PlanGrid Task Report - Mar 31, 2025

L05378_Hanover Towne Center FSU (NJ)

799 New Jersey 10, Hanover, New Jersey

#17 [DUCT 499] [NEW] CRITICAL (Turning Vanes Not Installed)

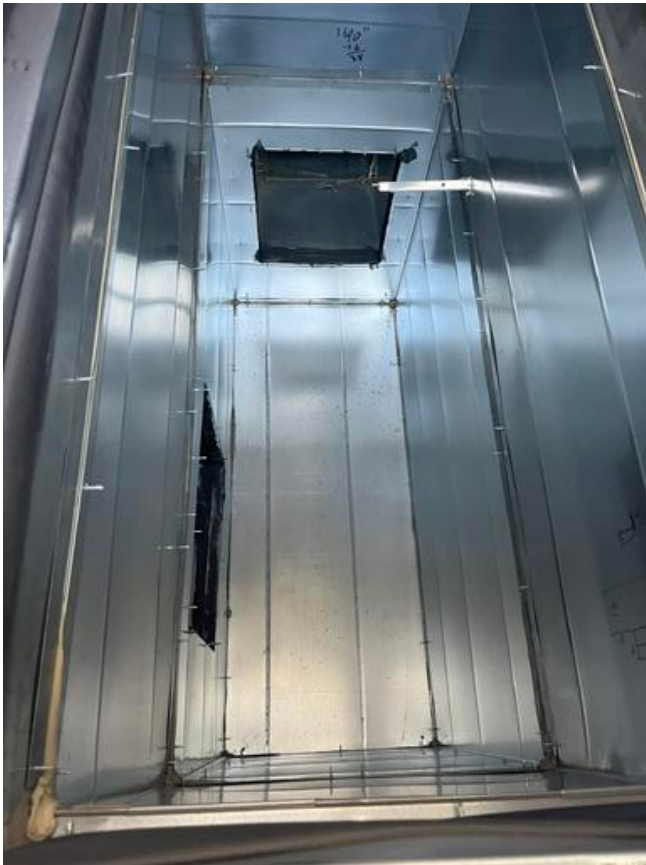
AC3 turning vanes are not installed on supply ductwork.
